**PLANNING AND DEVELOPMENT SERVICES STAFF REPORT**

**For Planning Commission Meeting of March 18, 2014**

**SUBJECT: South State Street Shell Gas Station/Drive-Thru Restaurant Site Plan for City Council Approval  
(2991 S. State Street)  
File No. SP13-058**

**LANDSCAPE PLAN**

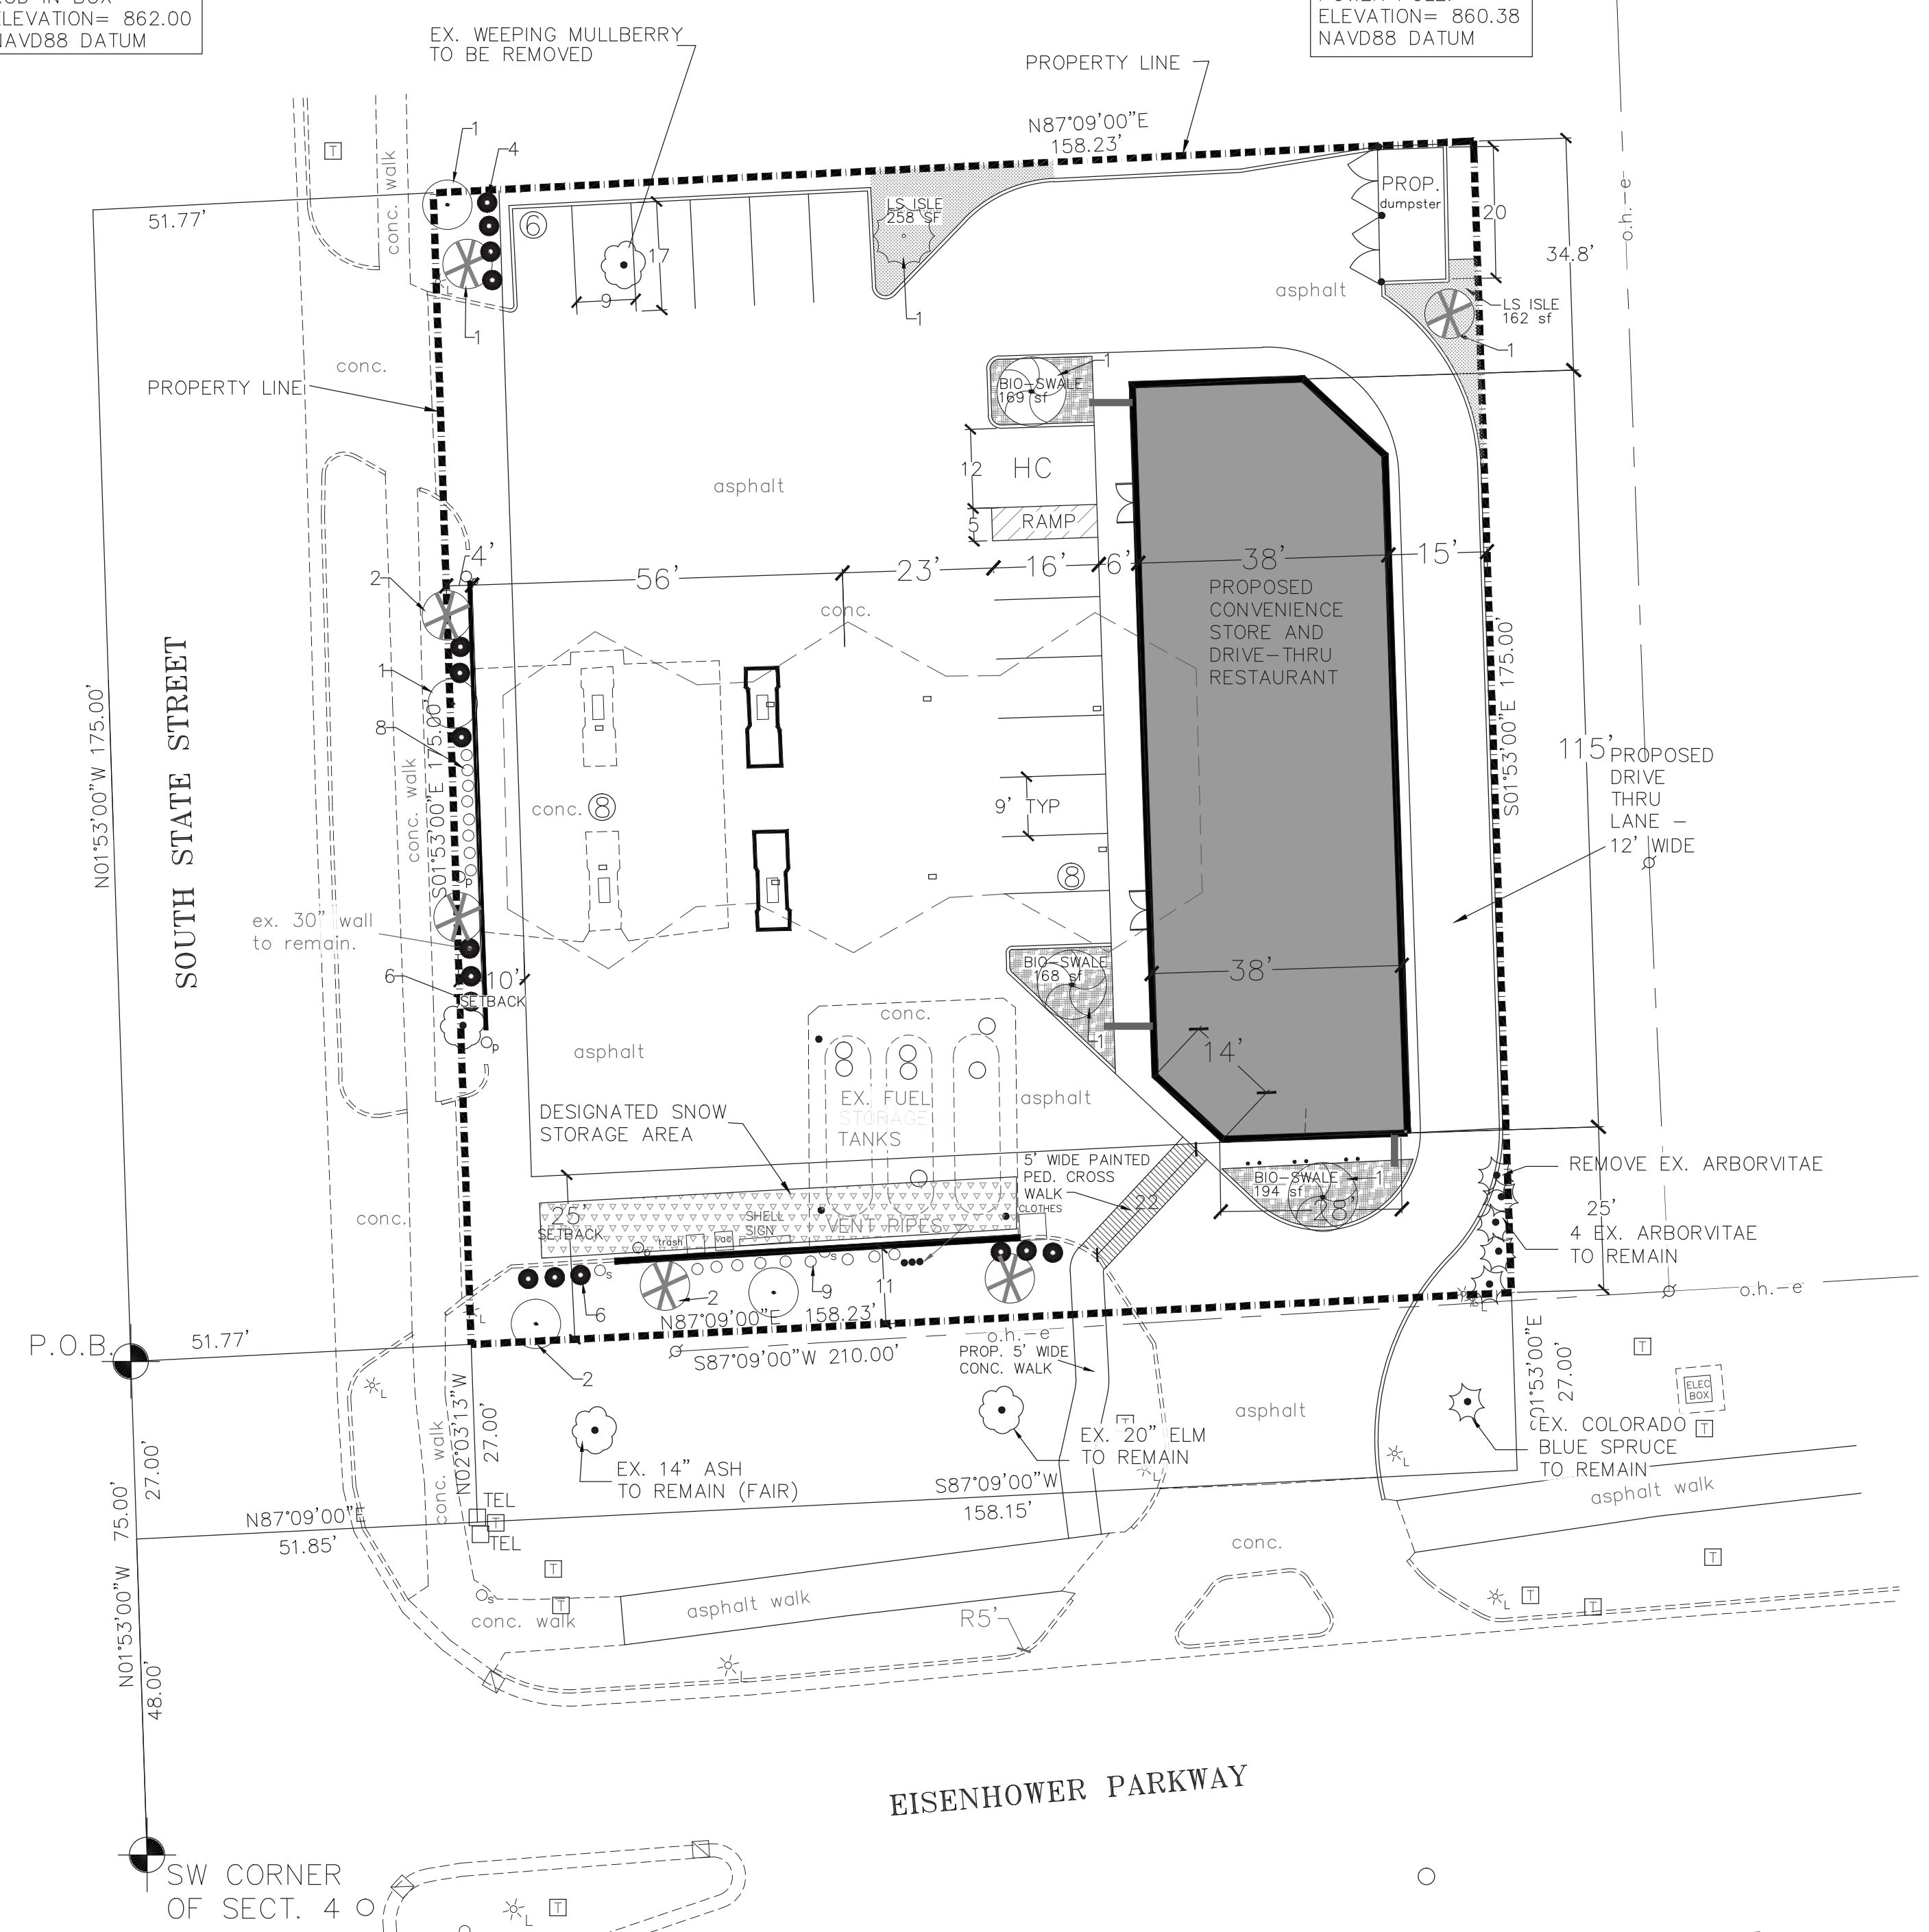
*A minimum 10-foot wide right of way buffer strip is required to screen from the vehicular use area. Currently the site has a 4-foot wide buffer strip, with a 30-inch screening wall and landscaping. This proposal adds landscaping in exchange for the 6-foot reduction in buffer width. Widening the buffer width would eliminate two existing pumps and their associated parking spaces.*

*The intent of the ordinance is to provide a screening buffer between the parking lot and the public right-of-way. A reduced buffer strip to 4-feet wide, along with additional landscaping and a 30-inch high wall screens the vehicular use area from S. State Street.*

Systems Planning – Forestry – Staff supports the landscape modification submitted by the petitioner to maintain the right of way buffer width of 4 feet along S. State Street due to a loss of required parking spaces if the landscape requirement were met. The petitioner is proposing more landscaping in the right-of-way buffers along both Eisenhower Parkway and S. State Street than is required.

Staff research shows the current right-of-way landscape buffer along State Street was originally site planned for a 5 foot width, which was a permitted exception for gas stations in the Landscape Ordinance in effect at the time. It is likely the planned five foot width was reduced to four feet sometime later in the recording of the new right-of-way. Staff supports the landscape modification request to reduce the buffer strip width from 10 feet to 4 feet. Increasing the buffer width to 10 feet would require the petitioner to relocate the two associated parking spaces and make the existing pump islands less accessible. The petitioner proposes additional landscaping to screen the vehicular use area and site from the public right-of-way in exchange for this reduction in width.

**LANDSCAPE MODIFICATION REQUESTED ALONG STATE ST. FRONTAGE:**  
 PER CHAPTER 62, 5:608 (c) (ii) AND (c)(iii) - STRICT ADHERENCE OF 5:602(1)(a) (LANDSCAPE BUFFER STRIP) WOULD RESULT IN LOSS OF PARKING REQUIRED PARKING SPACES AND IS AN EXISTING NONCONFORMING CONDITION IN A PREVIOUSLY APPROVED SITE PLAN. AN EXISTING 30" WALL IS LOCATED 4' FROM THE STATE ST. ROW AND NEW SHRUBS ON THE STREET SIDE ARE PROPOSED. THIS MEETS 5:602(1)(d) SPECIFICALLY FOR GASOLINE STATIONS.
